DRAWING REVISION HISTORY LISTING

PART NO: 1822803
DESCRIPTION: #412/#618 ROLLING POWER UNIT HYDRAULIC SCHEMATIC

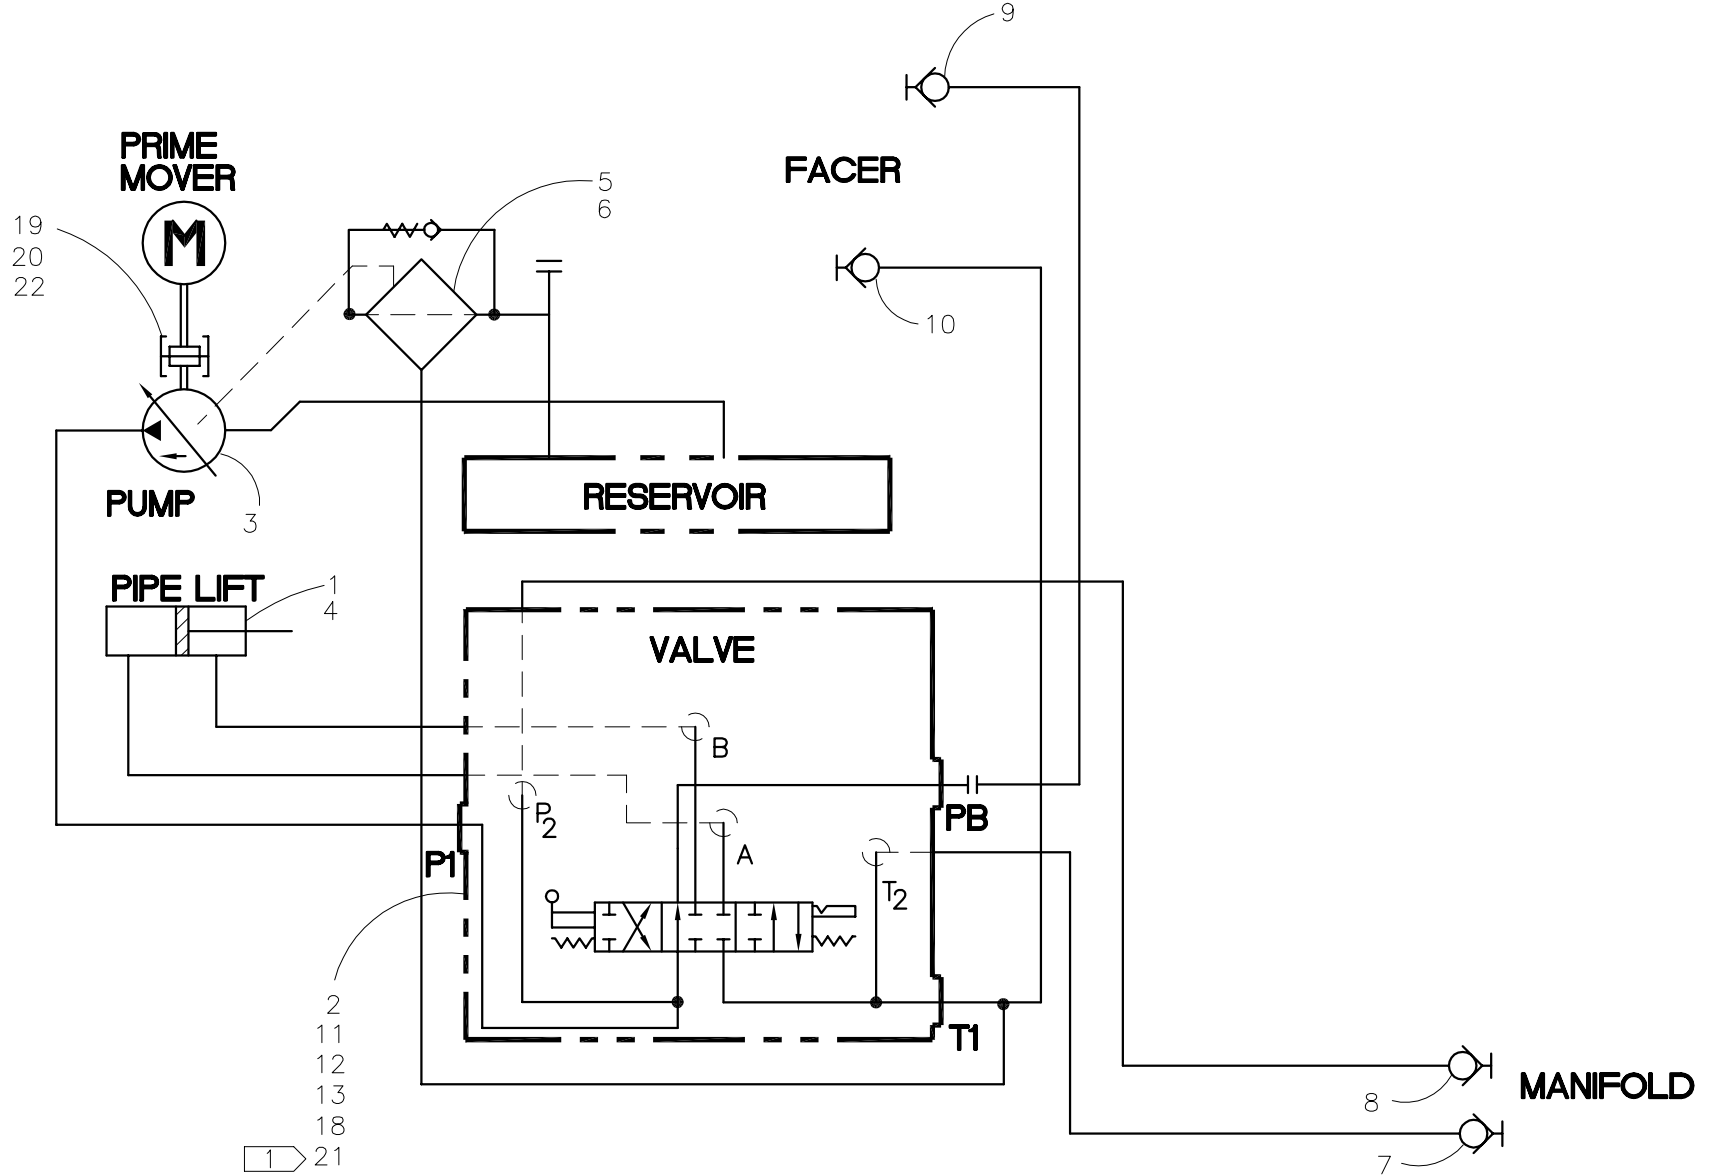
<u>APPR.</u>	<u>REV</u>	<u>DATE</u>	<u>BY</u>	<u>DESCRIPTION OF REVISION</u>
DWP	A	6/2/99	MRP	ADDED DETENT TO ITEM 2 AND SWITCHED THE A AND B PORTS.
SWB	B	8/14/01	RLE	ADDED MEF00077, VALVE HANDLE LEVER, QTY. (2) BECAUSE HANDLE NO LONGER COMES WITH VALVE.
SWB	C	04/23/03	BWW	REVISED ITEM 4 FROM MEB00104 TO MEB00128 TO INCORPORATE CARLSON WELDED CYLINDER. REMOVED ITEMS 14 1813602, 15 1813501, 16 MDM00068 AND 17 MCB00009. ADDED ITEM 22 1813402 BEARING HOUSING ASSEMBLY QTY 1. ITEMS REMOVED ARE INCLUDED IN ASSEMBLY. ADDED NOTE 1 FOR ITEM 21 MEF00077 WHICH NO LONGER COMES WITH VALVE AND CHANGED QTY OF ITEM 21 FROM 2 TO 1.
SWB	D	11/18/05	JAB	MOVED NOTE TO FACE OF DRAWING.
